T.I. no.: 2018 - 21 Updated: -	Topic: Software 1.10.9 and pressure switch modification
--	--

Date: 06.09.2018	Priority	Need for action
Affected machines: Schaeerer Barista	High	As soon as possible
From serial number: -	X Medium	X On next visit to the machine
As of date: -	Low	FYI only

Distinguishing characteristics

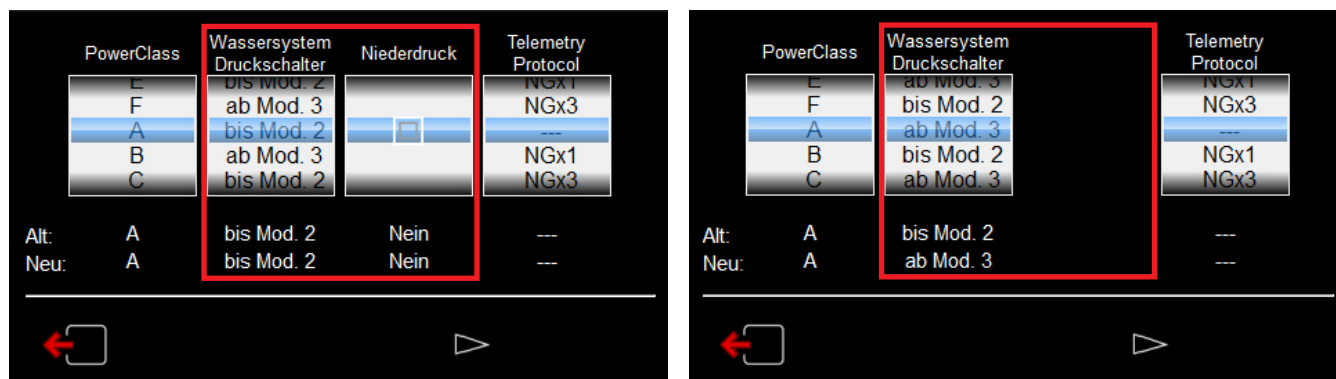
Pressure switch – 0.5 bar as of Mod.3

- Marking of head screw red
- Housing imprint in red
- Chrome-plated compression ring without inscription

Pressure switch – 2.7 bar up to Mod.2

- Marking of head screw white
- Housing imprint in white
- Chrome-plated compression ring with inscription

The hydraulic and electrical connections are the same for both pressure switch variants!

Service > Machine equipment > Water system pressure switch

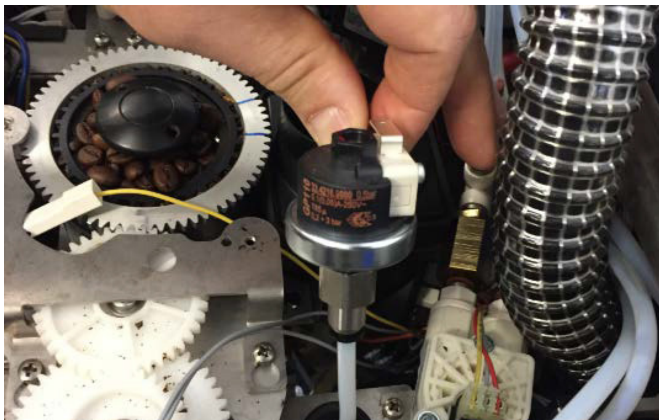
Software settings (from version 1.10.3 and higher)

The pressure switch used in a machine must be set in the software under "Machine equipment" on the NEW wheel – water system pressure switch.

- Setting: up to Mod. 2 -> if 2.7 bar pressure switch is installed, low-pressure operation possible
- Setting: as of Mod. 3 -> if 0.5 bar pressure switch is installed, no low pressure operation (checkbox – Low pressure – is hidden)

If a machine is converted to Mod.3, in the – Machine equipment menu – the new pressure switch with the setting – Mod. 3 – MUST be activated.
